TOWN OF PARADISE VALLEY

Smoke Tree Resort Major Special Use Permit Amendment 7101 E Lincoln Drive Work Session

Planning Commission
May 16, 2023

SCOPE – ARRIVAL BUILDING

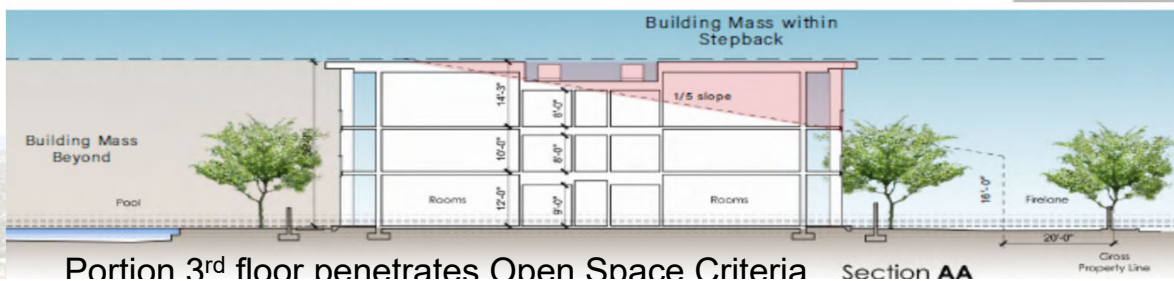
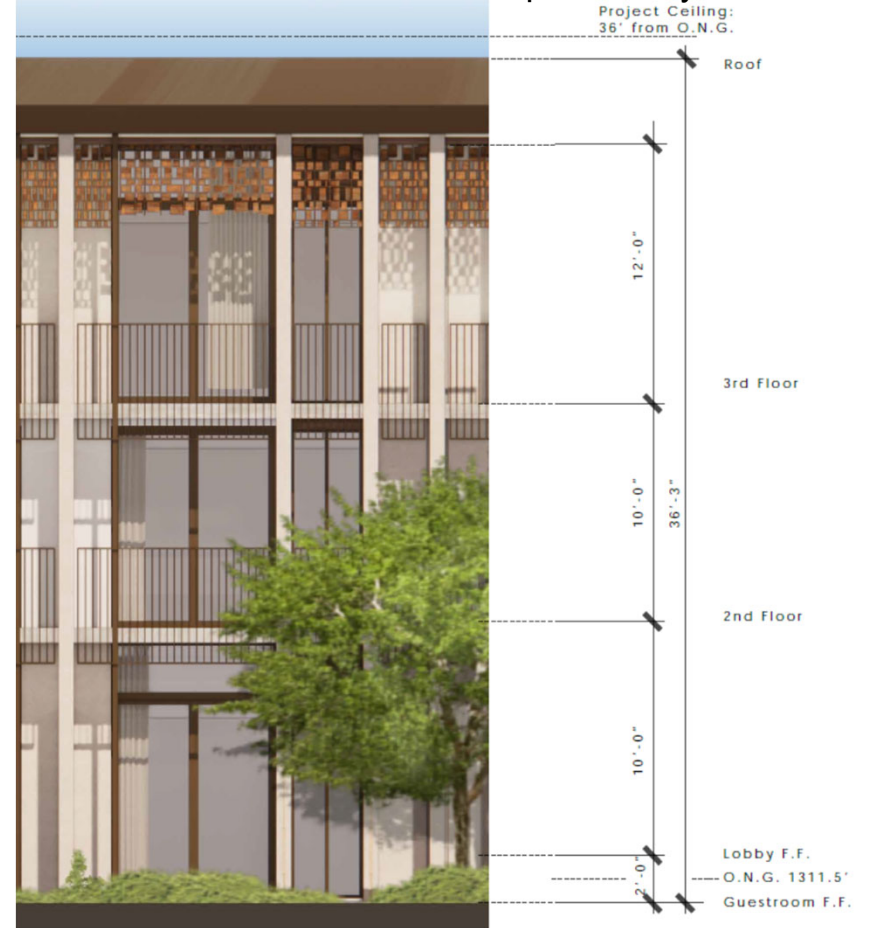
Maximum 36'3" measured from pool courtyard

SCOPE – ARRIVAL BUILDING

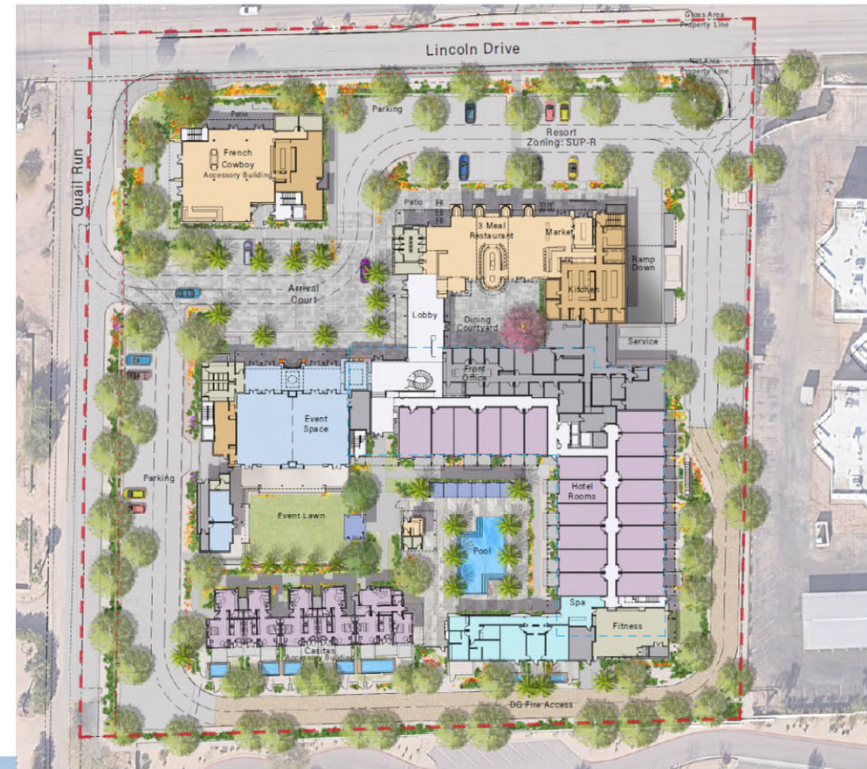
Maximum 36'3" measured from pool courtyard

3RD FLOOR 10

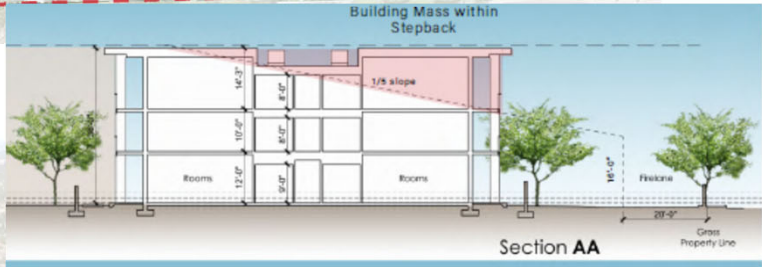
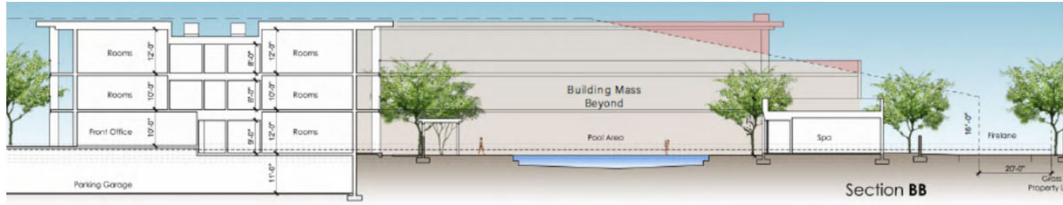
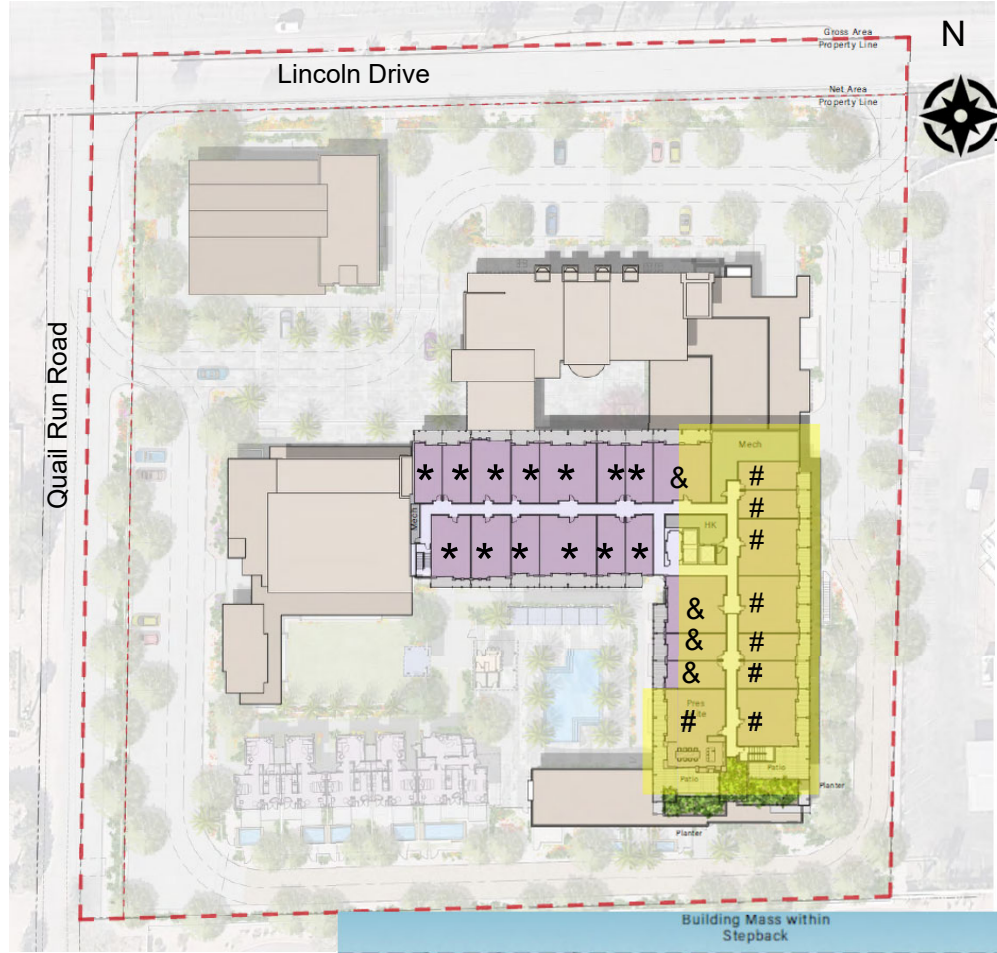
- No public areas, 25 guest units
- Units include private balconies
- 2 southernmost units have patios & setback from roof edge with planters
- Open Space Criteria encroachments
 - 13 rooms no encroachment (*)
 - 8 rooms almost fully encroaching (#)
 - 4 rooms minor roof portion encroaches (&)

SCOPE – FRENCH COWBOY BUILDING

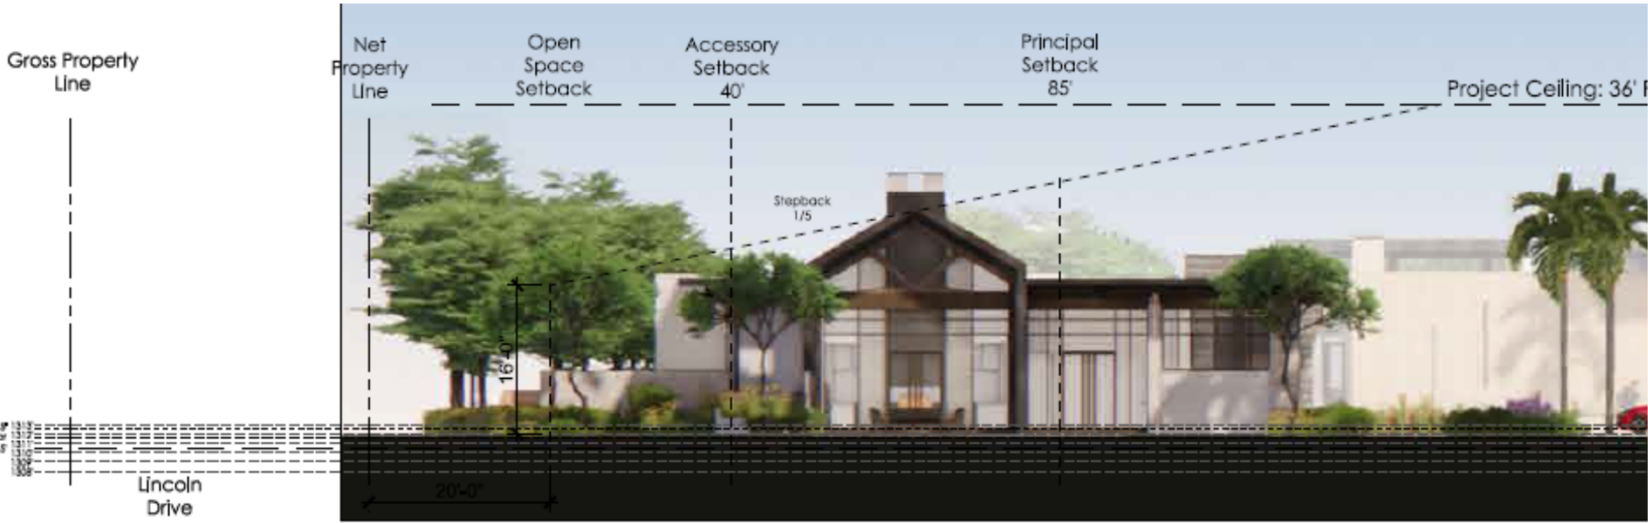
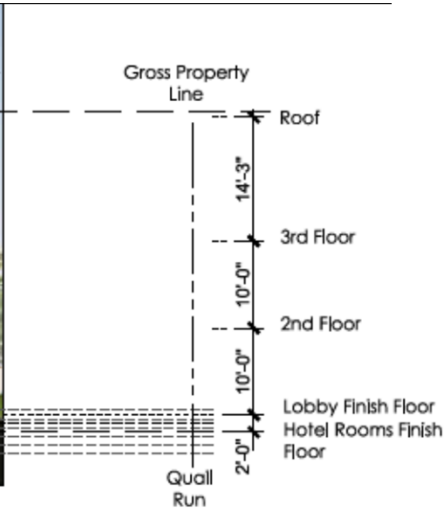
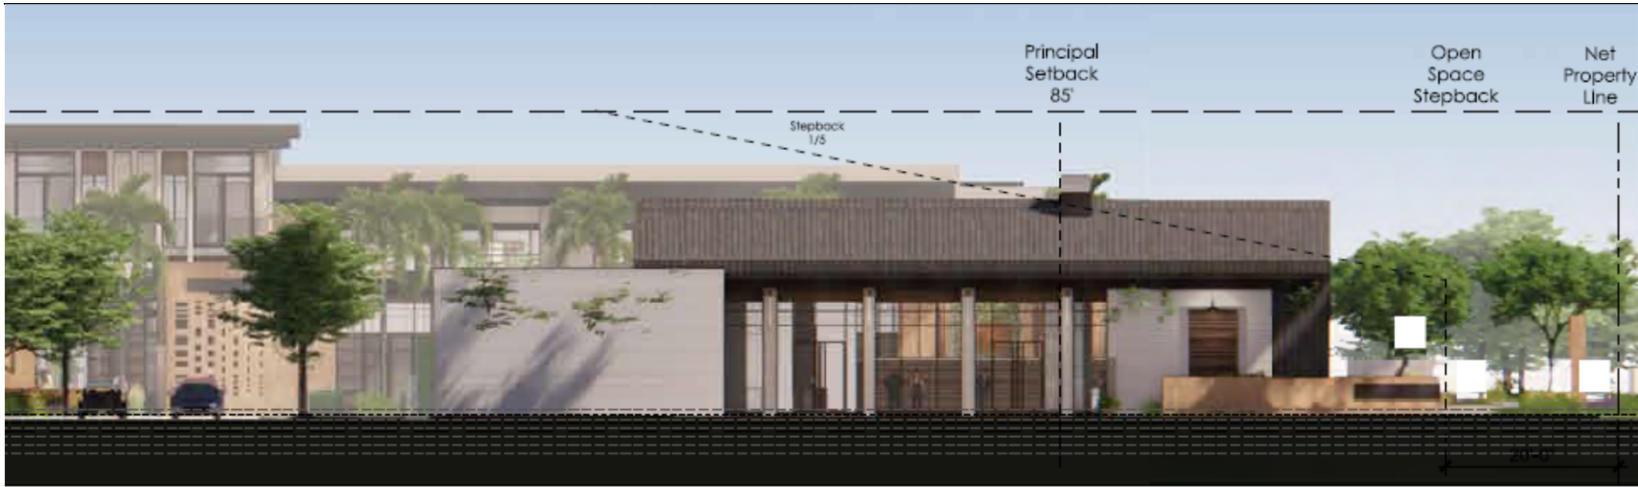
- Height
 - 18' (pitched roof/chimney higher)
 - 25'5" on cross section (clarify)
 - 1 story
 - Portions of roof/chimney penetrates Open Space Criteria and 24' height
- Setbacks
 - Not fully within 40' SUP Guideline
- Connects with the underground garage
- Architectural Design
 - Applicant design stated as "French agrarian"

[2] SOD NOISE/IMPACT

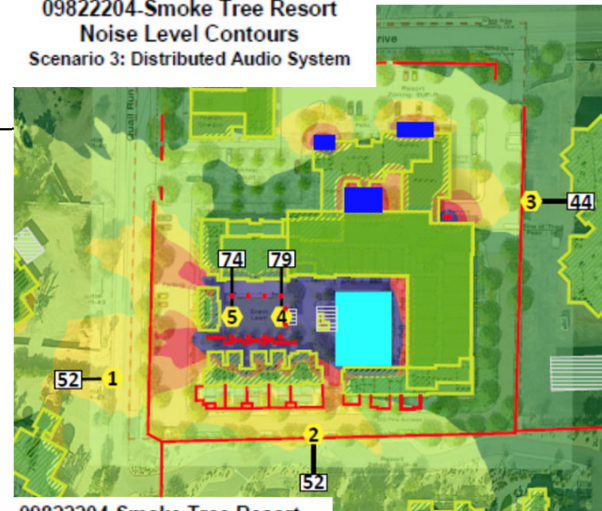
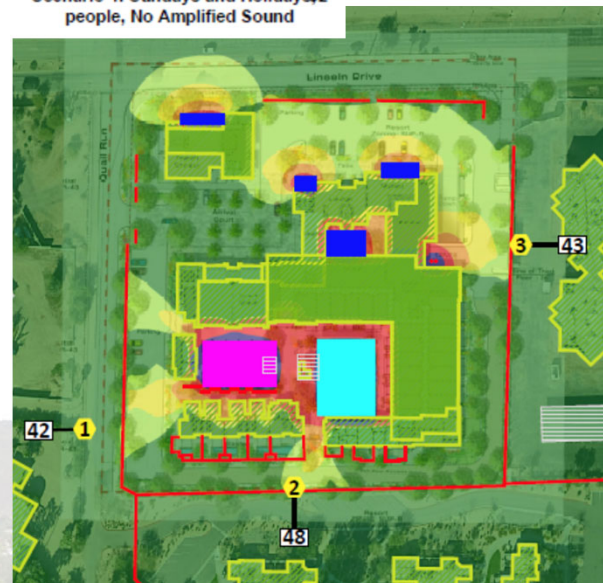
- Meets day limits
- Awaiting applicant response
 - Clarify impact of plunge pools/patios
 - Clarify referenced decibel levels
- Consideration of stipulations to meet night/holiday limit
 - Restrictions on use of certain outdoor areas after 10:00 p.m. and on Sundays/legal holidays
 - Technological noise mitigation and/or other design modifications
- Compliance with noise mitigation under review and will be revisited

[8] SOD – EXTERIOR LIGHTING

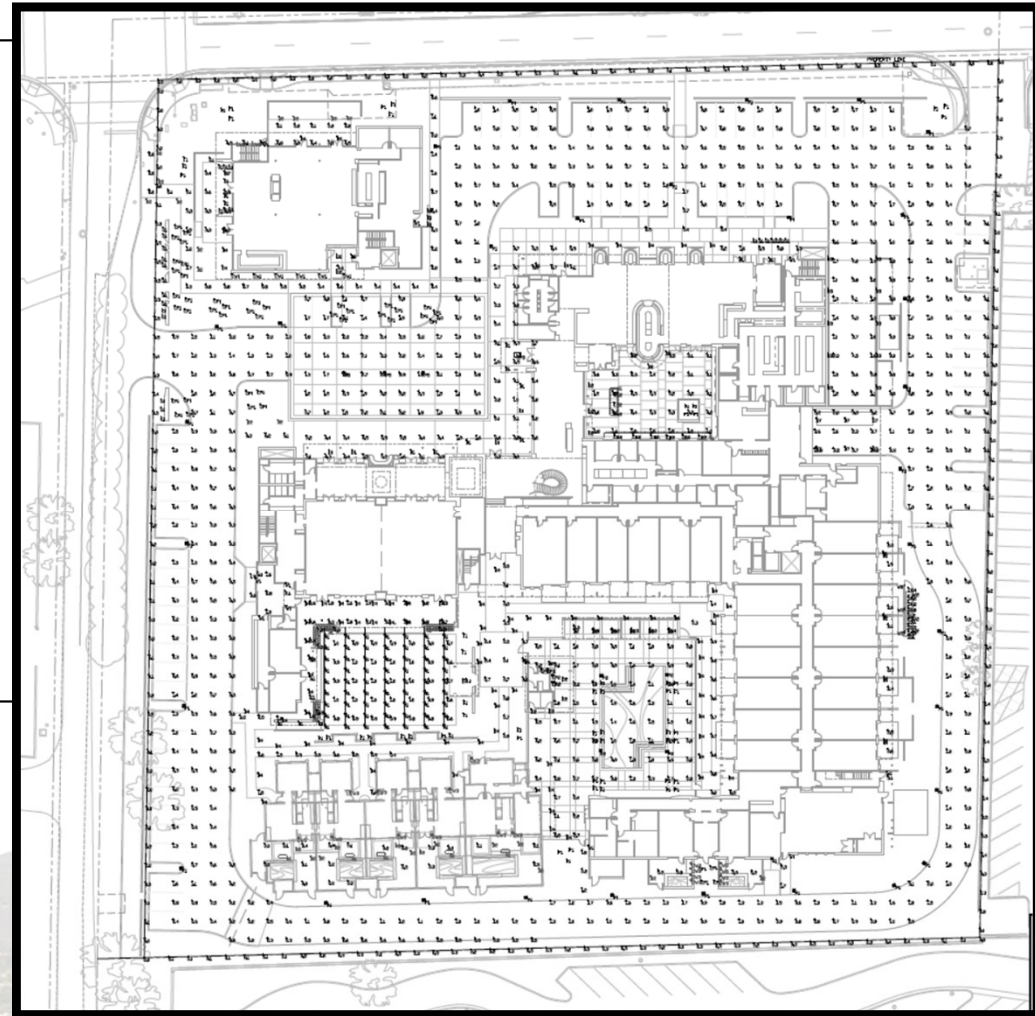
- *Maximum illumination at property line 0.75 foot-candles (at 5.0)*
- *Lighting appears to be within SUP Guidelines*
- *More detail needed*
 - *Hooding/shielding of fixtures CP1, M1, and N1*
 - *Fixtures for the second and third floors*

[12] SOD – WALLS/FENCES

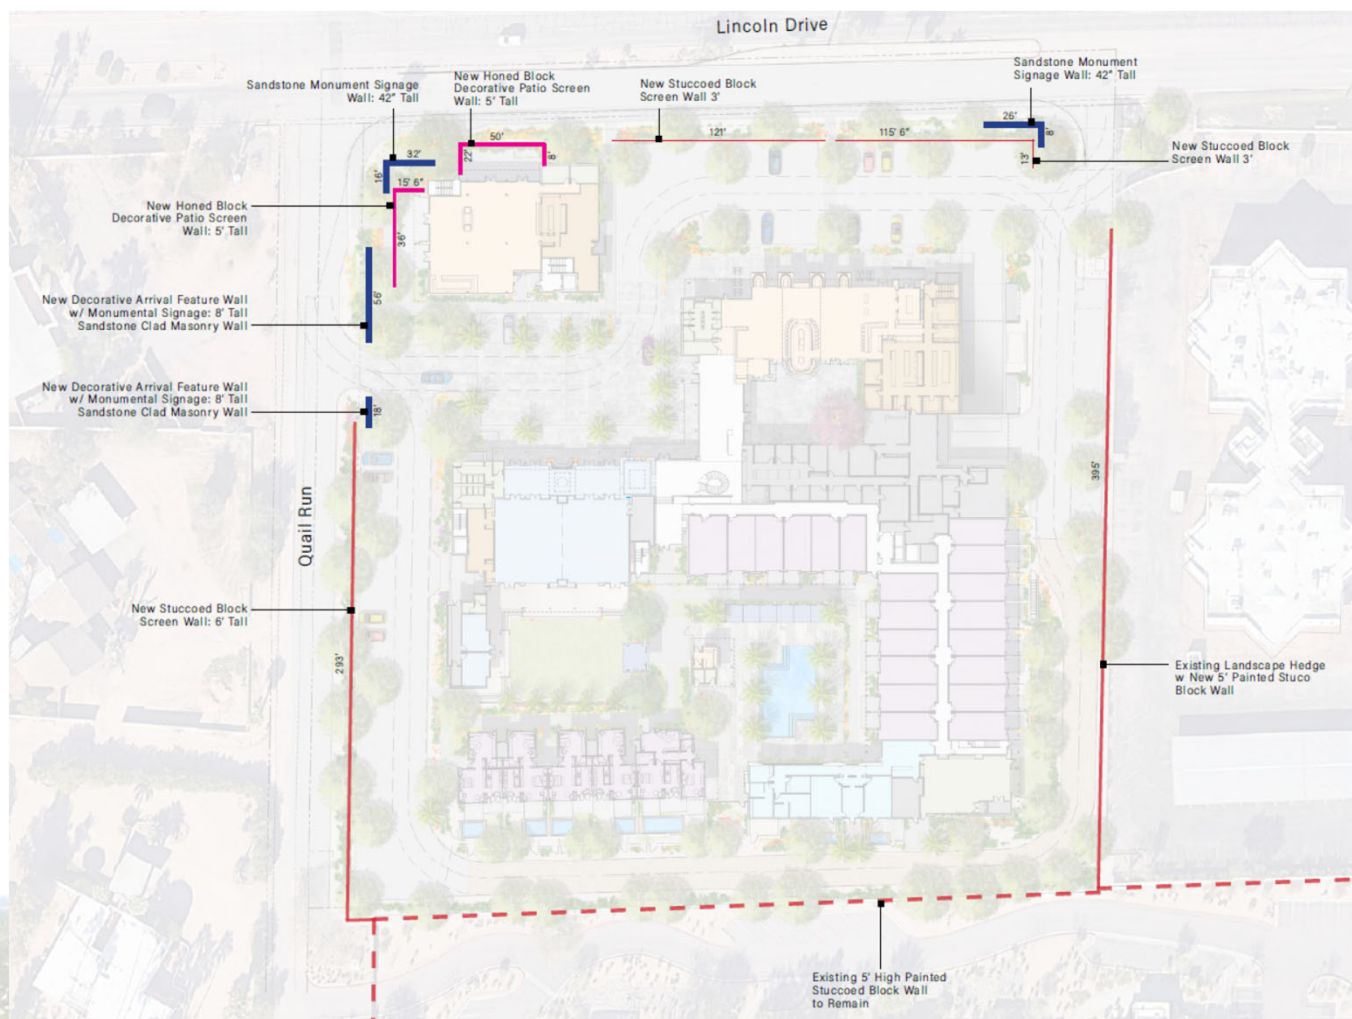
- *Parking screen wall along Lincoln Dr & walls along the east & south property lines are within SUP Guidelines*
- *4 feature walls, French Cowboy patio walls, and screen wall along Quail Run Rd are not within the SUP Guidelines*
- *More detail needed – explore options*
 - *Screening and/or relocation of APS cabinet at Lincoln*
 - *More clearly show setbacks on the plan*
 - *Show existing Andaz oleander hedge*
 - *Provide wall elevations*
 - *Modify 6' tall wall along Quail Run Rd to remove from right-of-way, larger setback, and redesign*
 - *Consider redesigning French Cowboy outdoor patio wall taller and with berms on outside mitigate noise*
